Subject: **Docket Nos. 50-206, 50-361 and 50-362**
Annual Radioactive Effluent Release Report - 2015
San Onofre Nuclear Generating Station (SONGS), Units 1, 2, and 3

- 1) San Onofre Nuclear Generation Station, Annual Radioactive Effluent Release Report 2015 January – December
- 2) Offsite Dose Calculation Manual Nuclear Organization San Onofre Nuclear Generation Station (SONGS) SO123-ODCM Revision 9, 11-9-15
- 3) Offsite Dose Calculation Manual Nuclear Organization San Onofre Nuclear Generation Station Appendix A, R_i Tables, SO123-ODCM-A, Revision 9, 11-9-15
- 4) Offsite Dose Calculation Manual Nuclear Organization San Onofre Nuclear Generation Station (SONGS) Appendix B Supplemental Information for Effluent Controls, SO123-ODCM-B, Revision 8, 11/2015

San Onofre Nuclear Generation Station
Annual Radioactive Effluent Release Report
2015
January – December

Figure 1-2

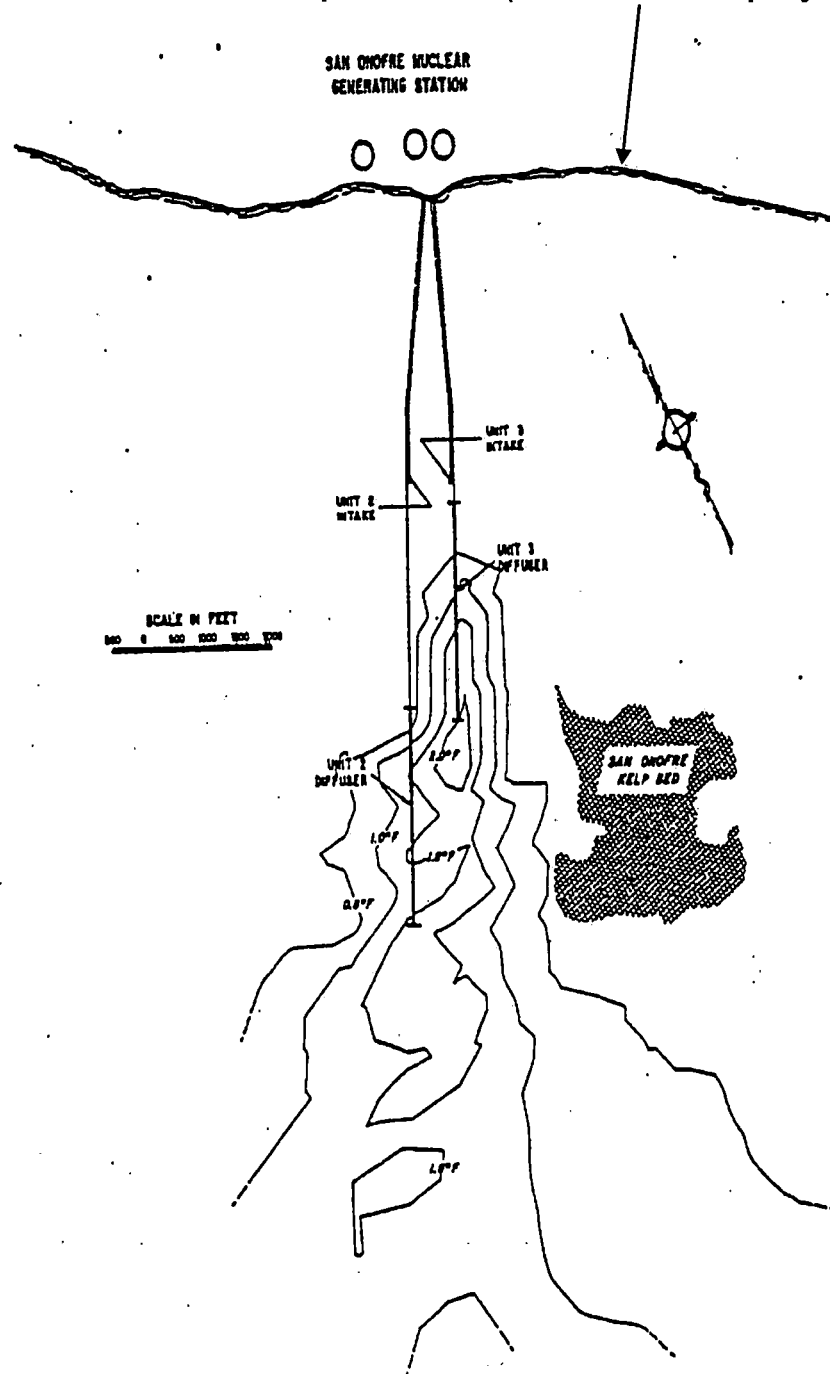
Page #	changes due to Revision	Reason
i-v	Update section titles and page numbers.	F
1-2	Remove batch and continuous release points of Radwaste Primary and Secondary Tanks, BPS Neutralization Sump, FFCD Sumps, Holdup Tank, CCW Sump, Storage Tank Area Sump, Auxiliary Building Sump; S/G Blowdown, S/G Blowdown Bypass Line and associated Footnotes. Add Footnote "g". Add Footnote "h".	D A A
1-3	Add Footnote "h".	A
1-5	Footnote h: added to clarify where liquid discharges may occur. Indicate Footnotes *, **, *** as DELETED.	A D
1-6	Remove Tech Specs and LCS that no longer exist.	D
1-7	Indicate liquid radwaste treatment system as portable. Revise Operational to Functional to match Tech Spec verbiage. Remove Tech Spec and LCS that no longer exist. Delete statements regarding plant Modes. Clarify processed liquids batch release.	R R D D R
1-8	Add site boundary clarification statement and line indicating boundary location.	A

Figure 2-2

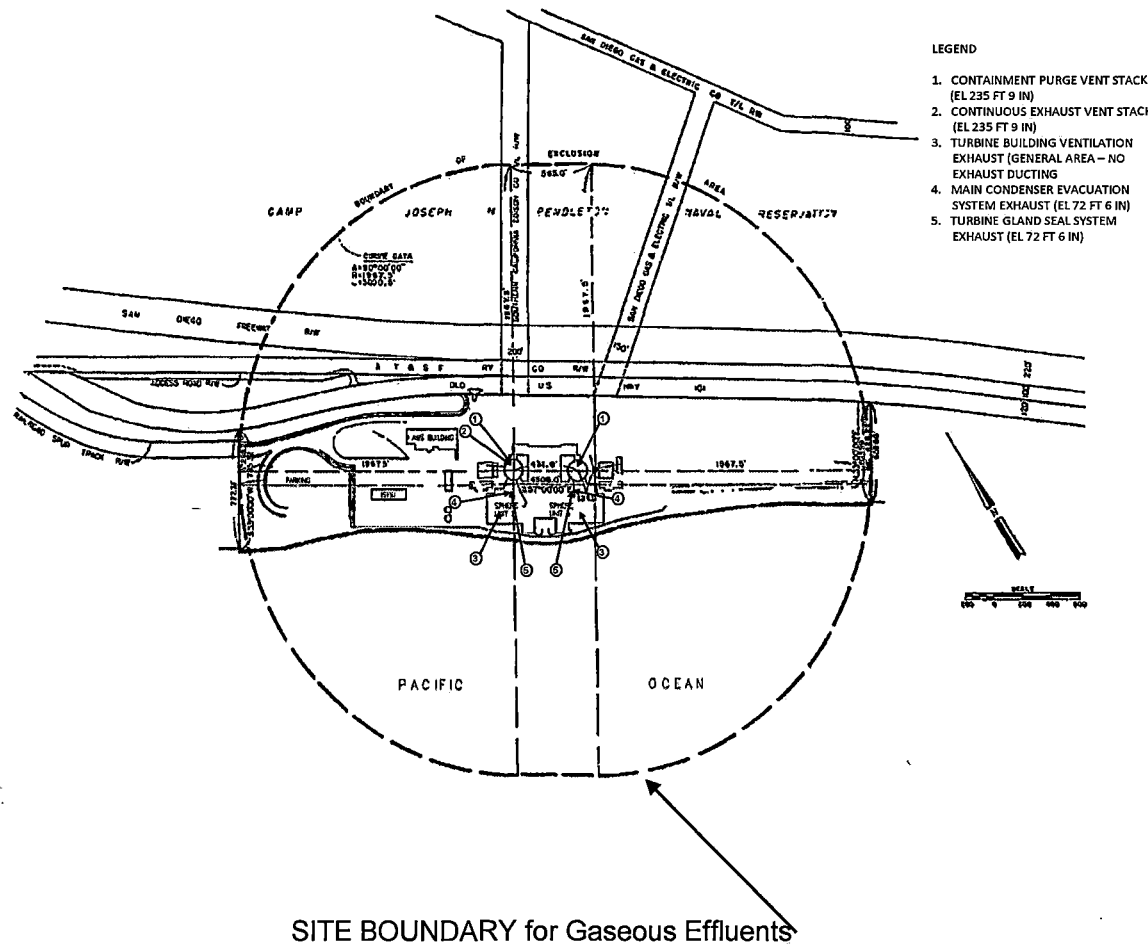
Indicate 2.4 Gaseous Radwaste Treatment as DELETED.	D
2-7	Identify site boundary line.	F
2-8	Remove no longer applicable release points. Update FLOC.	D F
2-9	Update FLOC. Clarify from where factor X/Q is obtained.	F R
2-10	Update FLOC.	F
2-11	Indicate 2.6.2 Condenser Evacuation System as DELETED. Deleted 2(3)RT-7828. Clarify that Containment Purge is Containment Mini-Purge. Delete NOTE regarding Containment Purge.	D D R D
2-12	Clarify that Containment Purge is Containment Mini-Purge. Deleted 2(3)RT-7828. Revise Flow rate factors. Delete Maximum Permissible Alarm Setting RT-7828. Indicate 2.6.4 Waste Gas Header as DELETED.	R D R D D
2-13	Indicate Table 2-3 as DELETED and remainder of page left blank.	D
2-14	Change Noble Gases to Noble Gas.	R
2-16	Change Noble Gases to Noble Gas. Clarify equation for ease of use.	R F
2-17	Clarify equation for ease of use. Correct grammar.	F F
2-18	Change number to word. Add parenthetical statement for Tables 2-7 and 2-8 location. Revise provider of Land Use Census.	F A R

Figure 4-5 SONGS Radioactive Liquid Waste Systems

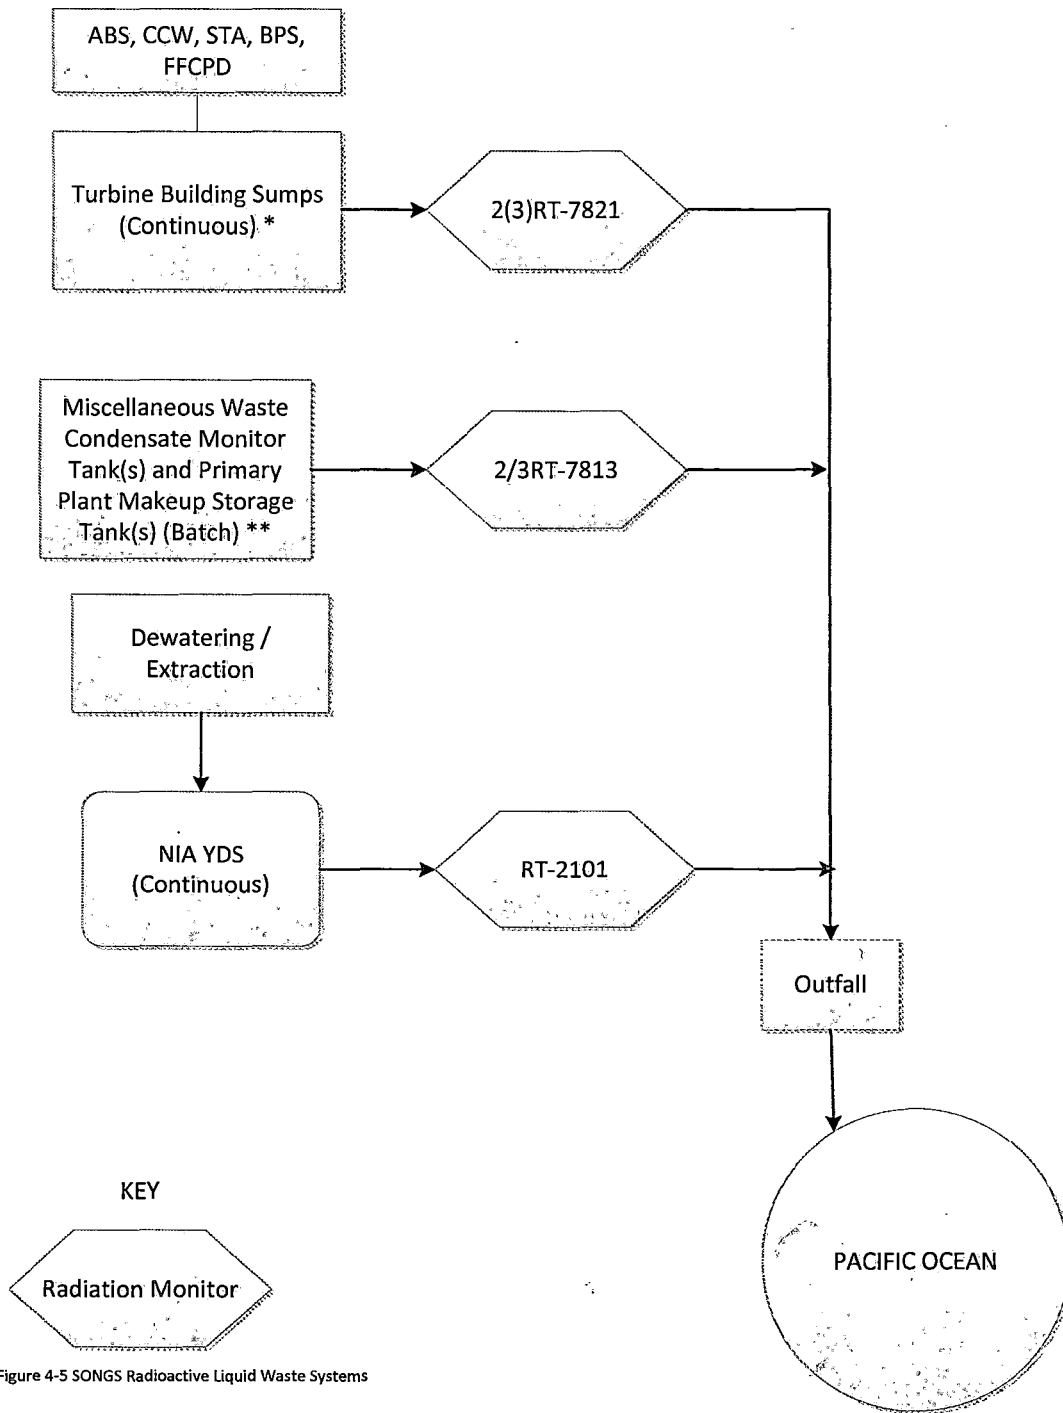
4-18	Revise Operational to Functional to match Tech Spec verbiage.	R
4-19	Clarify title of Figure and provide pathways to be used.	R
4-20	Clarify title of Figure and provide pathways to be used. Update FLOC.	R R
5-1	Delete LCS no longer in existence.	D
5-6	Correct Reg. Guide abbreviation and add revision number.	F
5-13	Change "reports" to "report".	F
5-15	Delete Footnote *** regarding PIC location. Clarify PIC location for future use.	D R
5-16	Delete Footnote *** regarding PIC location. Clarify PIC location for future use.	D R
5-17	Delete Footnote *** regarding PIC location.	F
5-18	Add new Footnote *** regarding the SONGS' garden. Update SONGS' garden distance. Correct typo.	A R F
5-20	Indicate Table 5-5 as DELETED and remainder of page left blank.	D
5-22 and 5-23	Revise location of environmental monitoring sample location.	R
